NOTICE OF DECISION

The Flats at Rogers Landing – Design Review – DR218-0010

The Flats at Rogers Landing – Design Review – DR218-0010

REQUEST: Design review approval for a 45-unit multi-family development

Attachment 1: Site Plan

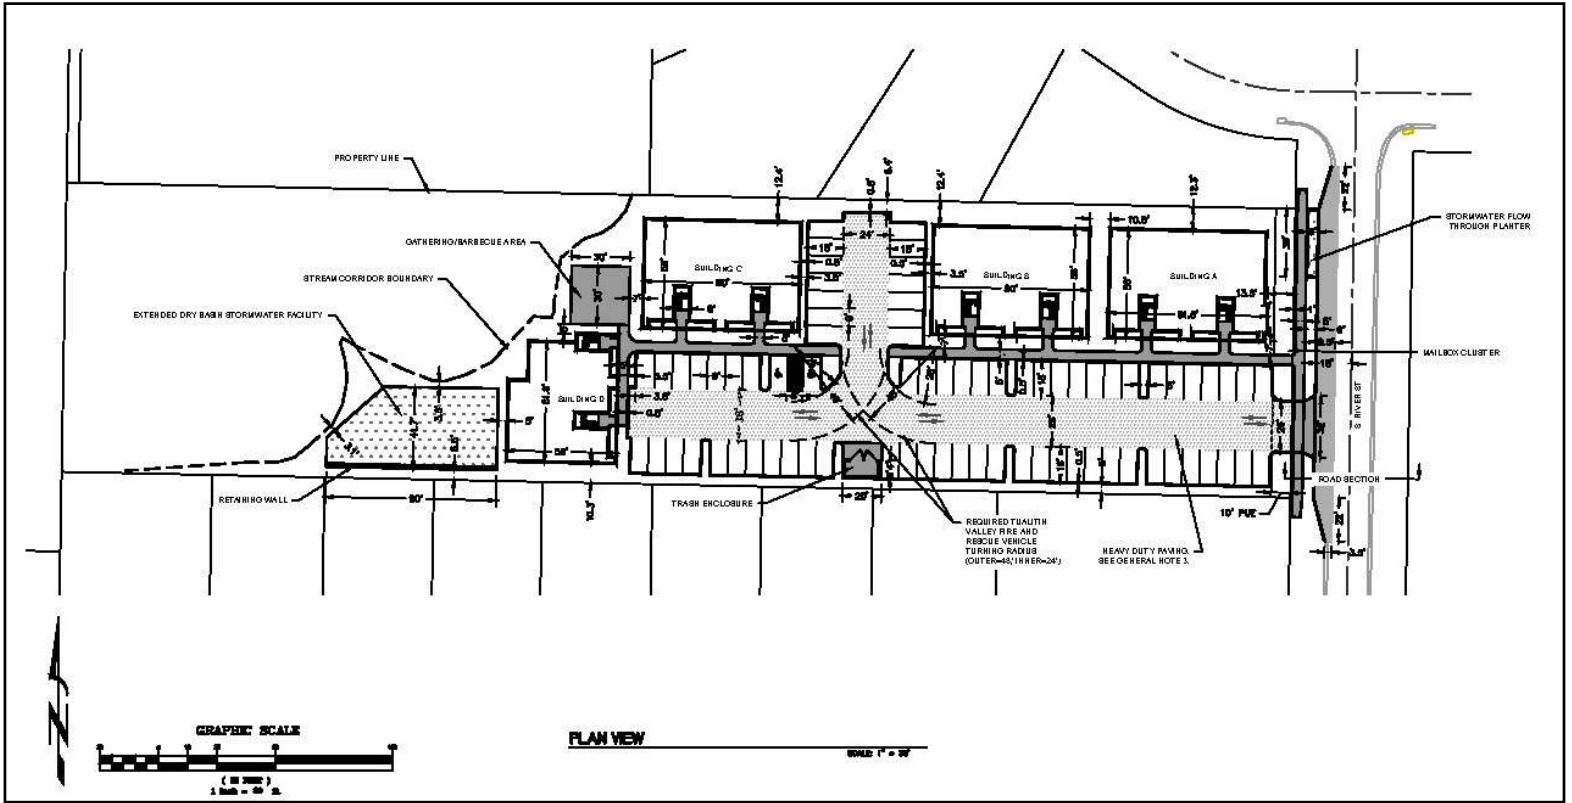
Finding: Landscaping is proposed within the 12 foot front yard setback along S River Street (Sheet C4). Because parking is proposed within the required front yard, the applicant shall submit a revised plan to the Planning Division for review and approval that shows no parking within the required front yard or request a Type I setback adjustment per NMC 15.210.02(A). With adherence to the aforementioned condition, the standard will be met.

Finding: The applicants' narrative states that the development plans show vision clearance triangles at the intersection of the access drive and S River Street; however, these are not shown. Prior to building permit issuance the applicant shall submit a revised site plan to the Planning Division for review and approval demonstrating how the vision clearance requirements of 15.410.060(B) & (C) are met. The vision clearance requirements will be met with adherence to the aforementioned condition.

accessible parking spaces does not show landscaping. If this area is not landscaped, the applicant does not meet the standard. Therefore, the applicant is required to submit a revised landscape plan for to the Planning Division for review and approval that satisfies the parking lot landscaping requirements of 15.420.010(B)(3).

Finding: The internal walkway system crosses the parking lot drive aisle west of Building B. The plans did not show how this crosswalk was to be marked in compliance with this code section. Therefore the applicant shall show a crosswalk that meets the requirements of 15.440.140(D) on the construction plans submitted to the building department. With adherence to the aforementioned condition, this standard will be met.
